Village of Anmore Memo

Re: Pinnacle Ridge Hillside Development – Update to Site Access

VILLAGE OF ANMORE REPORT TO COUNCIL

Subject: Pinnacle Ridge Rezoning Application – Bylaw No. 699-2024

PRELMINARY CONCEPT PLAN

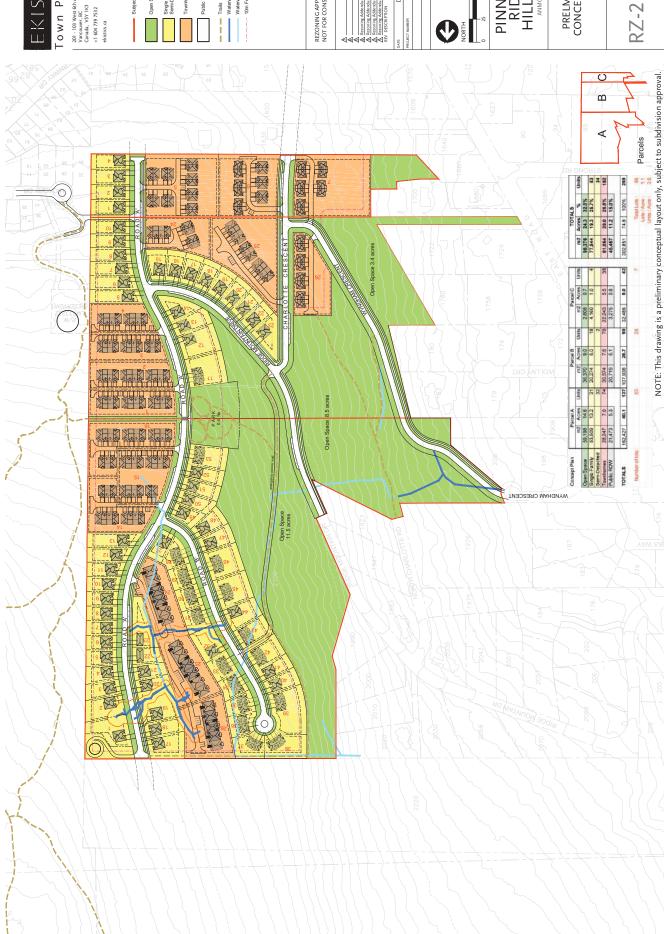
Since the completion of the staff report titled "Pinnacle Ridge Rezoning Application – Bylaw No. 699-2024" for the July 22, 2025 Regular Council Meeting, staff were advised by the applicant of proposed changes in the road access to the subject site. The current report outlines a proposed 6m wide secondary emergency access off Wynham Crescent and indicated that the feasibility of a dedicated road right of way was being assessed by the applicant's engineers as an alternative option. The applicant has since suggested that the dedication of a public road right-of-way in place of the emergency access is feasible and would connect Wyndham Crescent to Charlotte Crescent within the subject site. The proposed road would have a 20-metre width and a maximum slope grade not exceeding 15%.

The proposed road right of way has not been reviewed by staff; however, the staff report described the benefits of a secondary dedicated public road access to the site.

The current Comprehensive Development Plan, as included in the draft bylaw, does not reflect this updated road alignment. Should Council wish to proceed with the inclusion of the dedicated road right-of-way, the Comprehensive Development Plan will need to be updated in the bylaw prior to further readings.

The updated Comprehensive Development Plan and Comprehensive Development Zone Plan, illustrating the proposed public road, is attached for reference. Council's direction regarding road access can be incorporated directly into the recommendation section of the staff report.

Figure 2. Proposed Road Plan

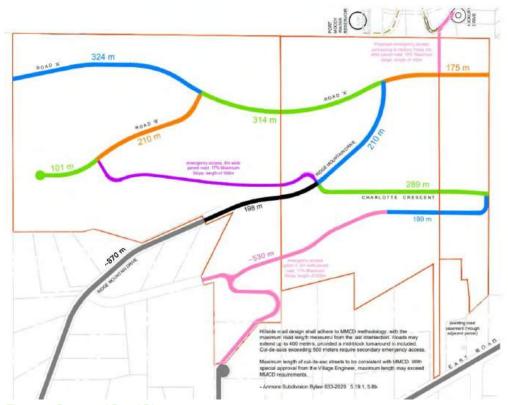
The proposed extension of Ridge Mountain Drive connects to new public road dedications (Road A and Road B) to the east. Road A may eventually link to adjacent lands to the north and south providing access to lands beyond should those lands be developed in the future (Figure 2.). The original plan included access to lands to the north through Road B, but this has now been changed to a cul-de-sac design to preserve density and allow for wider lots south of the road, avoiding development encroachment on steep slopes. The changes in road design may constrain access or future development potential for adjacent steep lands to the north.

The proposed public road rights-of-way include multi-use pathways along the road corridors and provide 64 parallel on-street parking spaces. In addition, an emergency access road, designed to double as a shared pedestrian pathway is proposed between 'Road B' and Charlotte Crescent to create a looped road network which is necessary to address cul-de-sac lengths to the north of the site that exceed the maximum length permitted under the Village's Subdivision and Development Control Bylaw No. 633-2020. Specifically, the Bylaw mandates that a secondary emergency access be provided where cul-de-sac lengths exceed 500 metres.

The initial rezoning proposal did not include emergency access to the site as the expectation was to achieve the extension and construction of North Charlotte Road toward Charlotte Crescent and was intended to be secured through land use agreements with neighbouring property owners to the south. However, those agreements have not been secured.

In place of the Charlotte Road connection, the applicant has recently proposed a secondary emergency access road connecting Wyndham Crescent to Charlotte Crescent to the south through a proposed strata road. The applicant is investigating whether it can be constructed as a 20m public road right-of-way pending engineering review. It would be beneficial to the Village and the Development if the emergency access from Wyndham were a dedicated roadway to the Village subdivision standard, as this offers unrestricted access to the public. The emergency access route would follow existing forest service roads to reduce grading and minimize tree removal. A second emergency access toward Hickory Drive in Port Moody has also been proposed, but this has not been approved by the City of Port Moody and would require intermunicipal consultation. The development is not contingent on the secondary access, but it would provide alternative access during an emergency for both Anmore and Port Moody residents.

Figure 3. Proposed Slope Map and Concept Plan

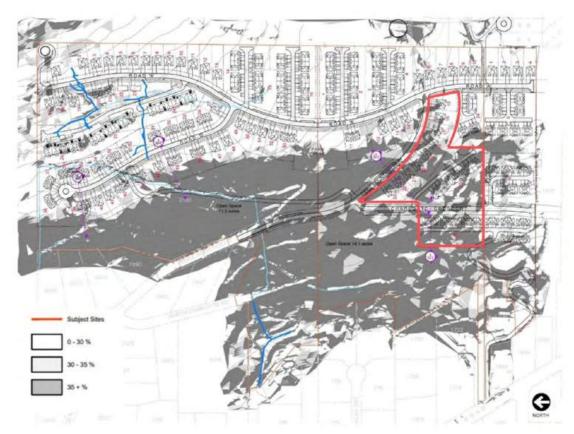
The majority of the site is clustered in areas less than 30% slope; however, certain lots are situated within sloped areas of 30%-40%, specifically Lots 15-23, 25 and 26, outlined in red on Figure 2. Lots 15-23 along Ridge Mountain Drive may be partially regraded with the construction of the new road.

Currently, Lot 26 is proposed to be accesses through a strata road and will require grading irrespective of Charolotte Crescent Road construction. The strata road is proposed to connect to the emergency access road towards Wyndham Crescent; however, Staff note that the existence of the road is not required to provide access to the emergency access road as a connection can be directly achieved off Charlotte Crescent.

Staff received geotechnical comments from GeoPacific Consultants (Attachment 7), which relay the suitability of the site for construction on steep slopes up to 40% provided that a detailed design and grading drawings are completed and accompanied with a slope stability assessment for lots greater than 30%.

Should Council wish to proceed with the current site plan including lots within slopes of \geq 30%, Staff recommend that a detailed topographic survey be completed for the subject site and that further assessments and a detailed grading plan be required as a conditions of development which may include site-specific steep slope hazard assessments to identify risk and mitigation measures and to confirm that the lots are safe for development. All development must adhere to the Subdivision Development Control bylaw and Village Zoning

Map 3 below displays the potential location of the ideal option (purple) and the alternative option (pink).

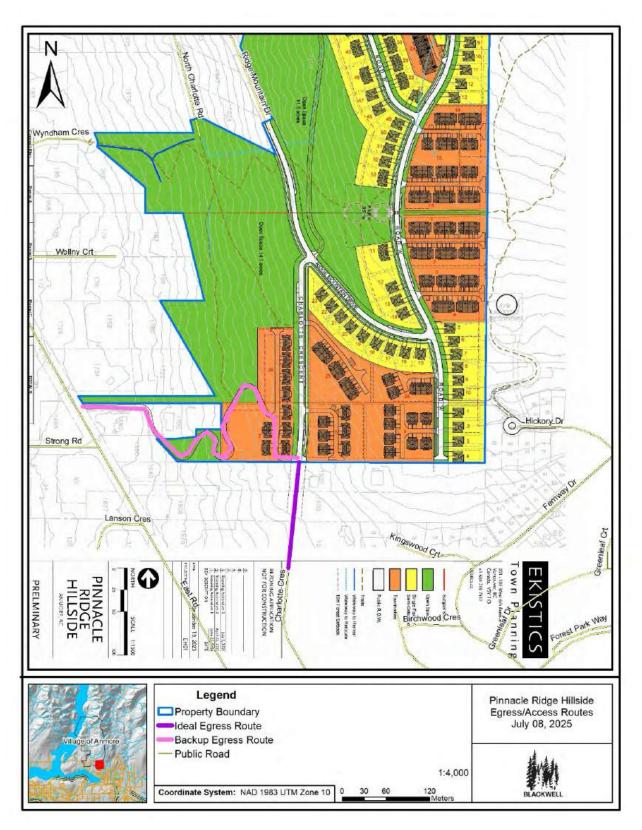
1) The spur off of Ridge Mountain Drive should be extended to the south, outside of the development, and intersect Charlotte Crescent.

This secondary access/egress route is highly recommended in order to increase evacuation efficiencies and emergency response in the event of a wildfire. If this route is not approved, then an emergency access route that zigzags down the southwest portion of the property and eventually meets up with East Road should be implemented. Also, as per communications with Aaron Baerg of Ekistics Town Planning, another emergency access route at the north side of the property is being considered.

All of these options require consultation with respective property/landowners in areas where the roads extend outside of the Pinnacle Ridge Hillside development's property line.
